UNITED STATES PATENT AND TRADEMARK OFFICE

APPLICATION NO.	FILING DATE	FIRST NAMED INVENTOR	ATTORNEY DOCKET NO.	CONFIRMATION NO.
10/659,224	09/10/2003	Alfons Resing	09187-US	5757
30689	7590	12/27/2005	EXAMINER	
DEERE & COMPANY ONE JOHN DEERE PLACE MOLINE, IL 61265			KOVACS, ARPAD F	
			ART UNIT	PAPER NUMBER
			3671

Office Action Summary	Application No.	Applicant(s)
	10/659,224	RESING ET AL.
	Examiner Árpád Fábián Kovács	Art Unit 3671

Pivoting about an
approx. horizontal
axis

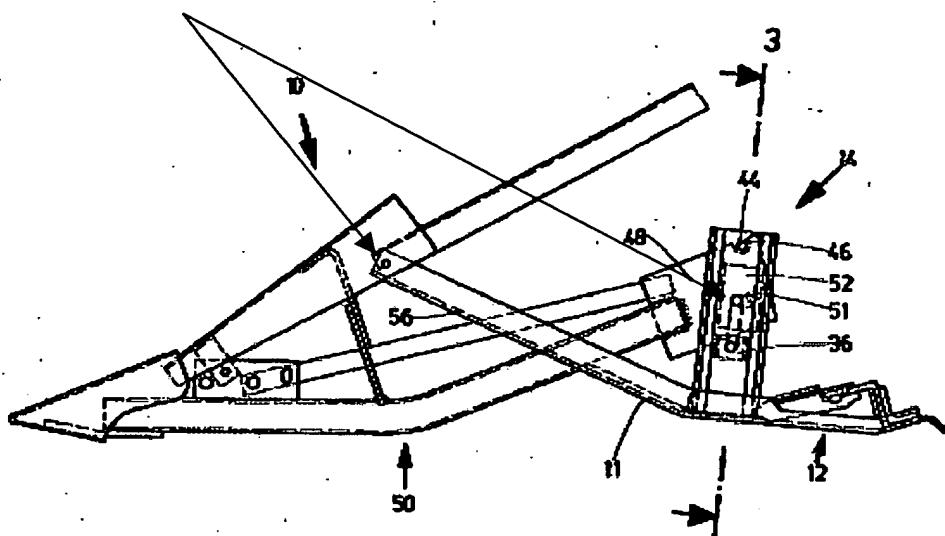
Doll discloses & shows:

in re claims 1 & 16: a stalk divider supported on a bearing (ref 51), **can be** deflected sideways relative to the intake/pick-up device & transverse to the forward direction (abstract), supported pendulously on the pickup device (English Abstract, line 3);

in re claim 2: to pivot about an approx. horizontal axis (see fig 1, for example at forward end member ref 56);

in re claims 3, 4: to slide transversely sideways relative to the forward direction (abstract; & see fig 2);

in re claim 5: connected pendulously with a parallelogram guidance linkage (fig 1, ref 48);

in re claim 6: to float freely (fig 1).

In re claims 11-15: the design choice of the shape of the divider as shown in fig 2 is conical / circular with the forward region having a smaller radial dimension than of a second section located behind the first section or stepped sections (gradual).
